ADDENDUM NO. 1
TO
CITY OF AUBURN, MAINE
WIN 18651.00 LPA PROJECT – MILL, MAIN, BROAD STREET
IMPROVEMENTS
August 2, 2022

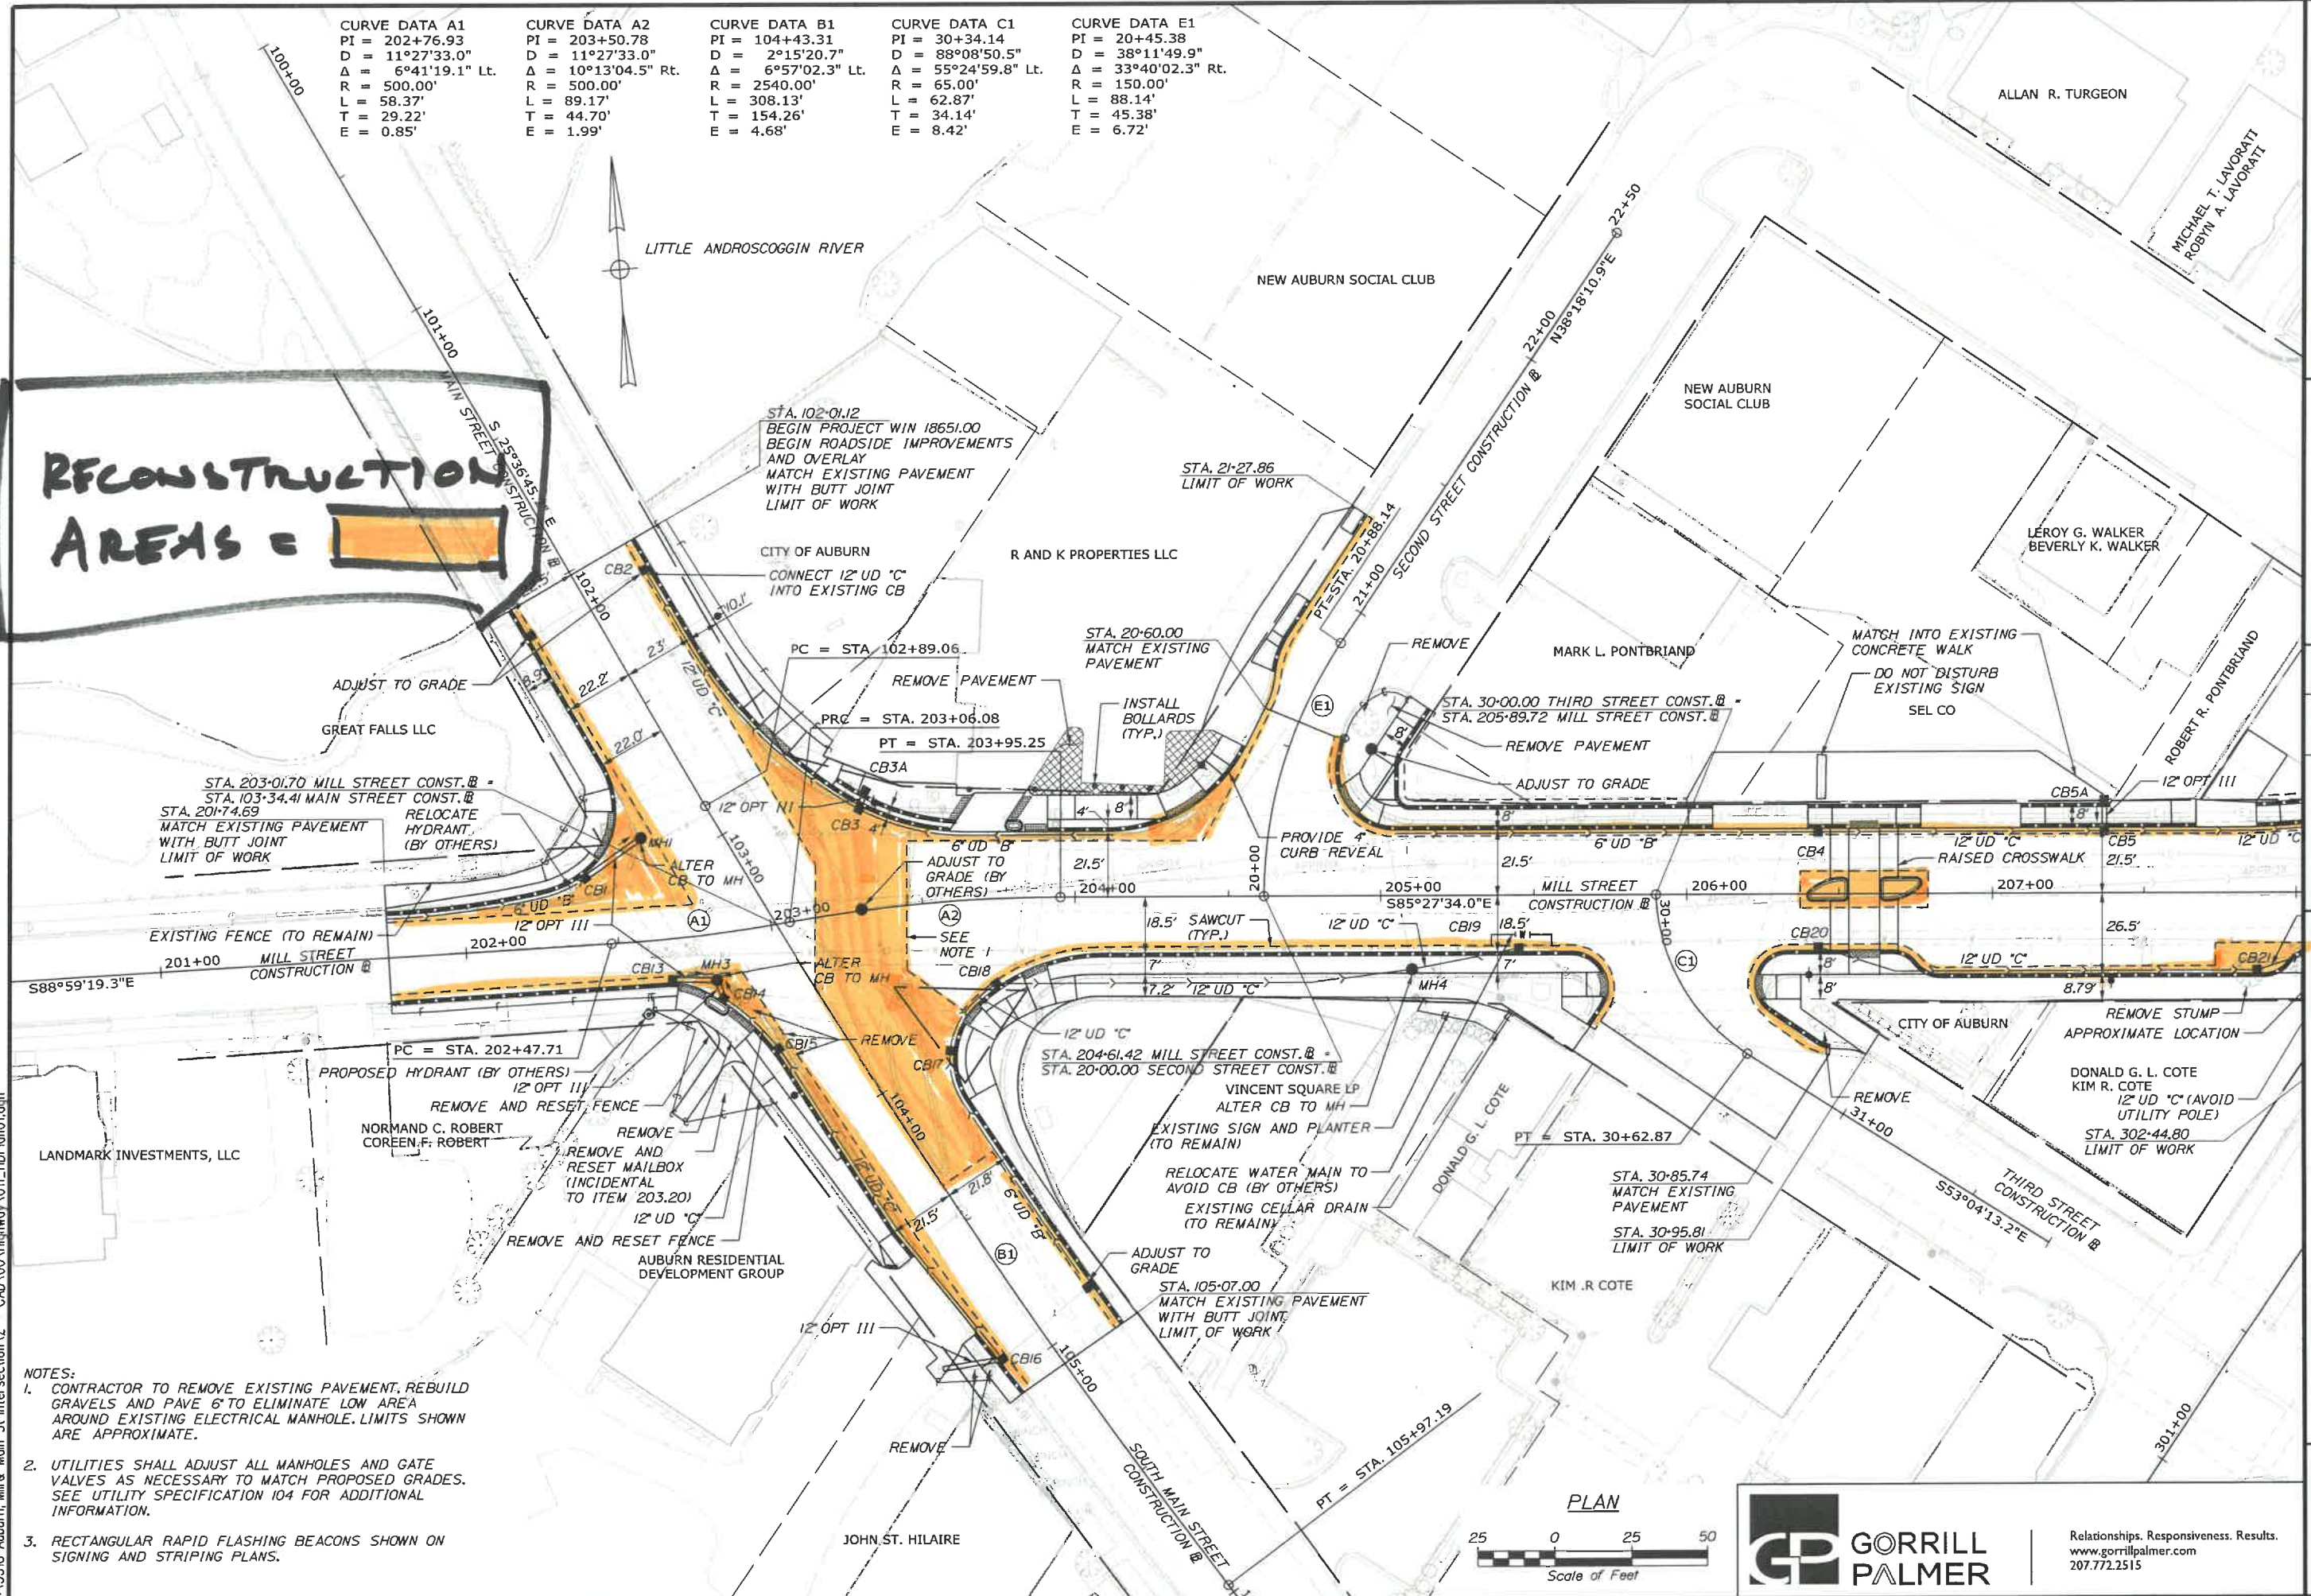
1. Question: Please clarify limits of milling. Limits of milling are not clearly called out.
 - a. Answer – Variable depth milling will be required to achieve the proposed pavement cross slopes as shown on the cross sections. This project includes a pavement overlay with variable depth milling and shimming as needed to achieve the cross section cross slopes and grades. See attached graphic for limits of reconstruction areas.

20. Question: Can you clarify the scope of work on Mill Street between stations 201+74.69 and 203+50?

- a. Answer – We agree the sawcut limits between the pavement overlay and reconstruction areas in this section are confusing on the plans. See attached graphic for limits of reconstruction areas.

RECONSTRUCTION AREAS = [Orange shaded area]
